### ADDENDUM NO. 1

### TOWER GROVE CONNECTOR, PHASE 1

DATE: 11/19/24 LETTING NUMBER: 8779

# 3.0 Basis of Payment

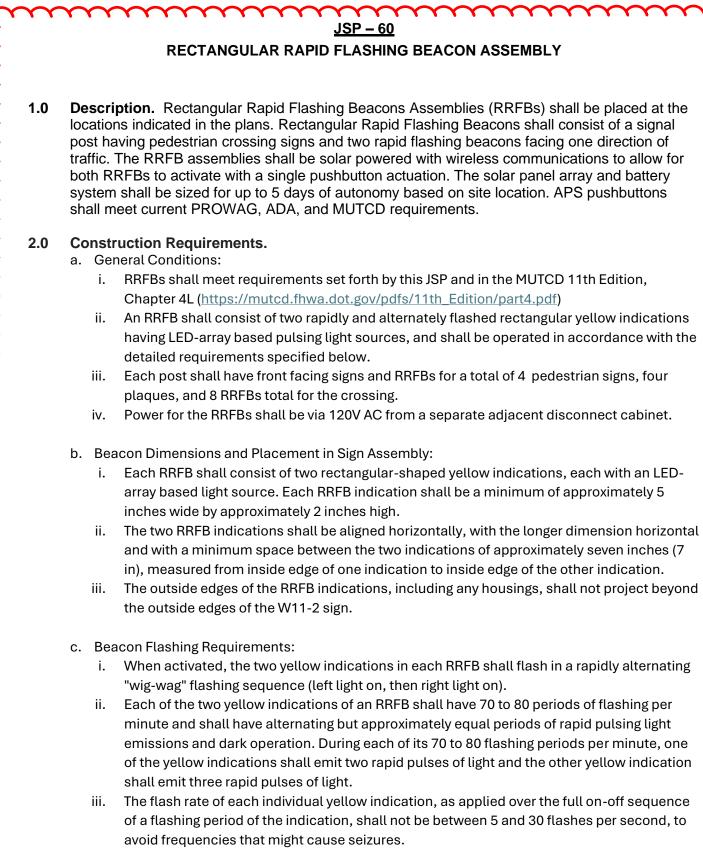
- Revise "JSP-11 Railroad Requirements", Section 3.0 Basis of Payment, for this JSP.
- Add "JSP-60 Rectangular Rapid Flashing Beacon Assembly".

All work necessary for compliance with this provision shall be included with the pay items "RAILROAD PERMITS" per LS and "RAILROAD FLAGGERS" per DAY. Additionally, the Contractor will be responsible for paying invoices submitted by Union Pacific Railroad for work performed by UPRR personnel. This work is estimated at \$95,000, based on the Railroad's Material and Force Account Estimate as stipulated in the Construction & Maintenance Agreement. The Contractor will be reimbursed for payments made to UPRR through the pay item "PAYMENT FOR WORK PERFORMED BY UPRR". This pay item will reimburse the Contractor for the total cost billed by UPRR, with no additional markup.
